SKETCH PLAT **DEPARTMENT OF** **TRANSPORTATION** **3RD ADDITION**

DEPARTMENT OF TRANSPORTATION
AND CITY OF WICHITA

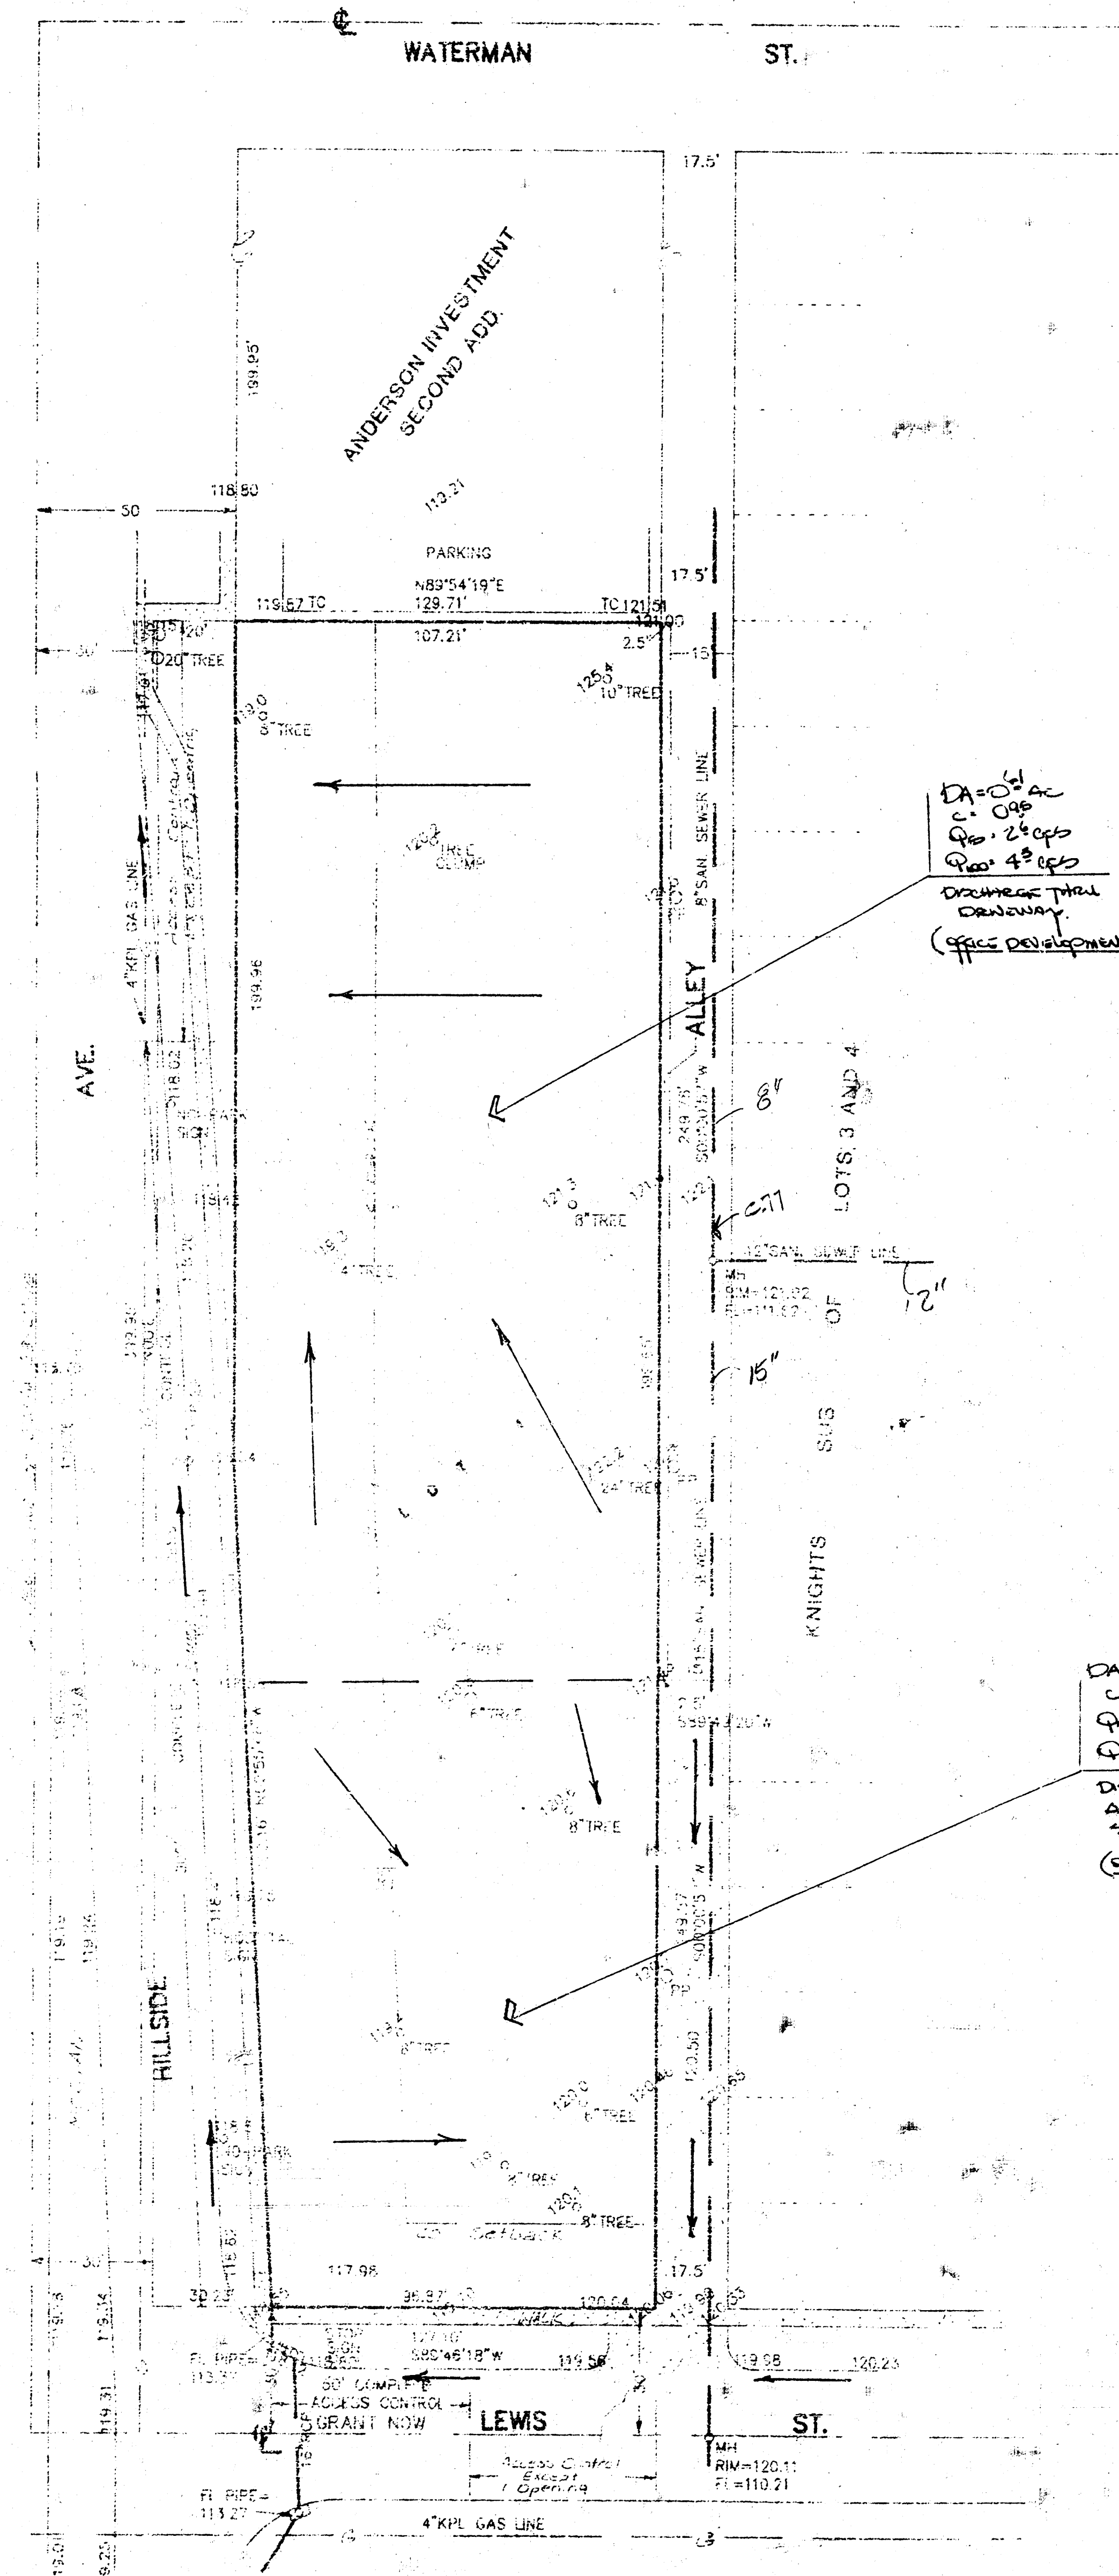
Prove existing storm
sewer can take
all this water & tell
what existing runoff
to to SS is.
And prove won't flood
street
Failed Alley? Brent
